Charlotte Department of Transportation

Memorandum

Subject: Rezoning Petition 15-014: Approximately 4.66 acres located on the northeast corner at the intersection of Park Road and Sharon Road (**Revised 2/13/15**).

Figure 1

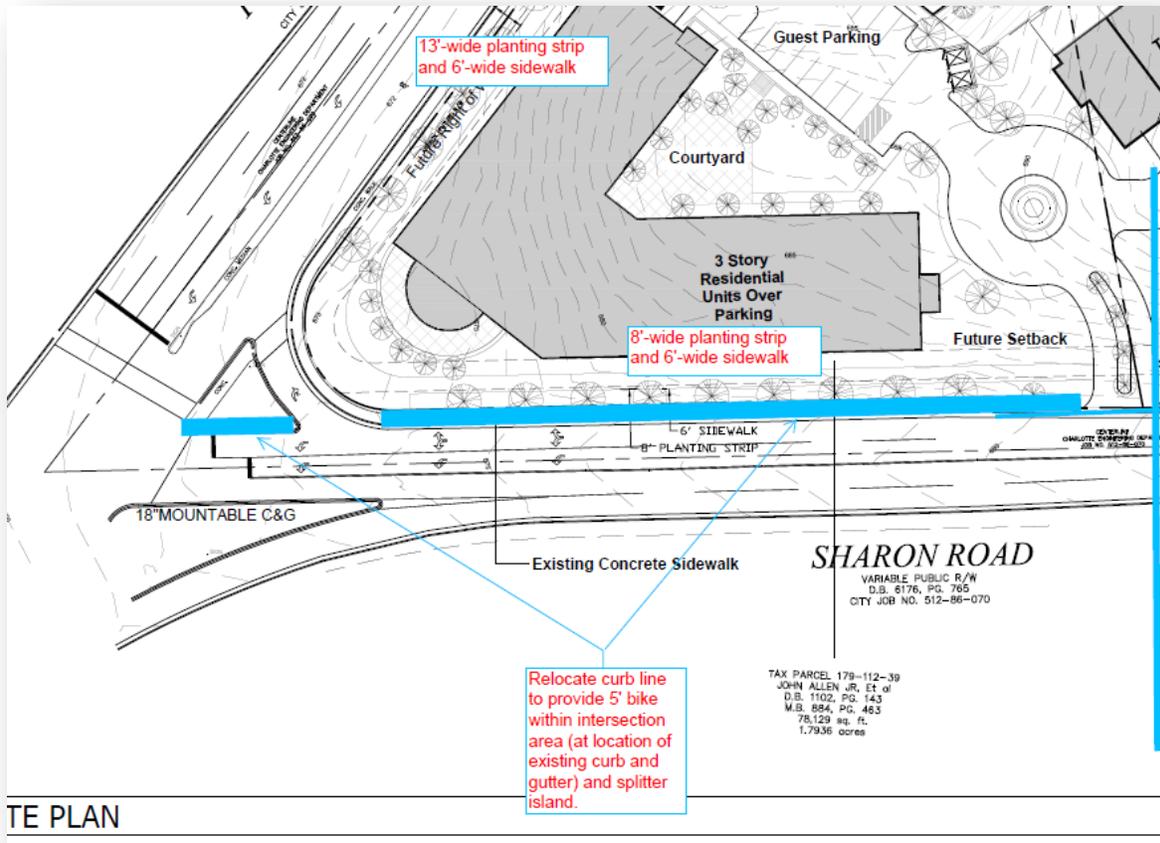
2. Sharon Road has an Urban Street Design Guidelines (USDG) classification of Avenue. The future curblines of Sharon Road should accommodate three 11-foot travel lanes and two 5-foot bicycle lanes (43 total feet of pavement width), with an 8'-wide planting strip and 6'-wide sidewalk. Please revise the plan view with dimensions and notes, and revise Transportation notes to reflect the following improvements along the site's Sharon Road frontage.

- a. At the intersection of Park Road along Sharon Road within the existing splitter island, relocate the curb line to create a 5'-wide bicycle lane.
 - b. Along the existing site's frontage where curb and gutter is present, relocate the curb line to create a 5'-wide bicycle lane.

- c. Establish the new back of curb location at 24' from centerline where curb and gutter does not exist.
- d. Along the entire Sharon Road frontage, establish an 8'-wide planting strip and 6'-wide sidewalk.

See the Figure 1 and Figure 2 below.

Figure 3

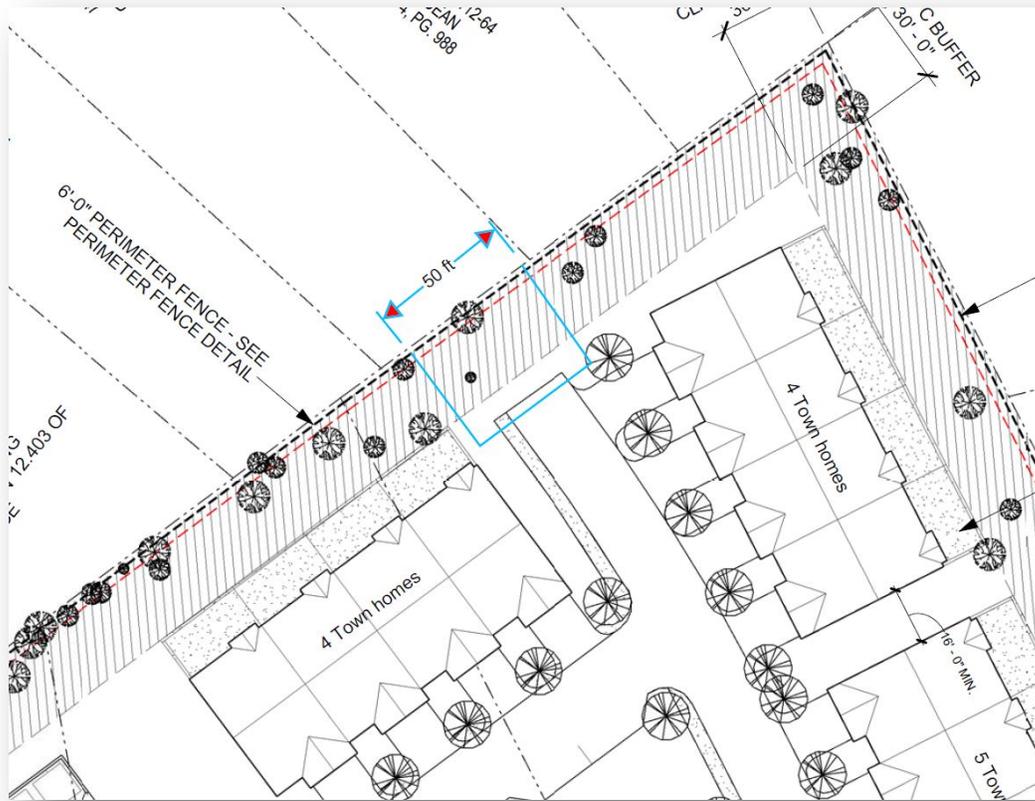
4. CDOT requests that the petitioner revise the site plan to include dedication of a minimum 50'-wide easement in which the internal private street can be extended at a future date should the parcels to the north redevelop. See Figure 3 below.
